STAFF REPORT

CONCERNING APPLICATION FOR A CERTIFICATE OF APPROPRIATENESS

Application Number: 2018-0621C

Property Location: 815 Arch

Premium Colonial 6' Rail Kit

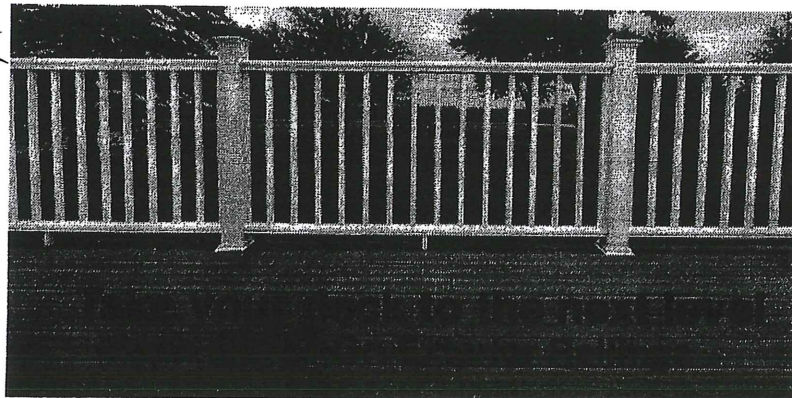
1. Replace existing wooden railing with multiple spans of 72” x 36” White Vinyl “Premium Colonial 6’ Rail Kit”
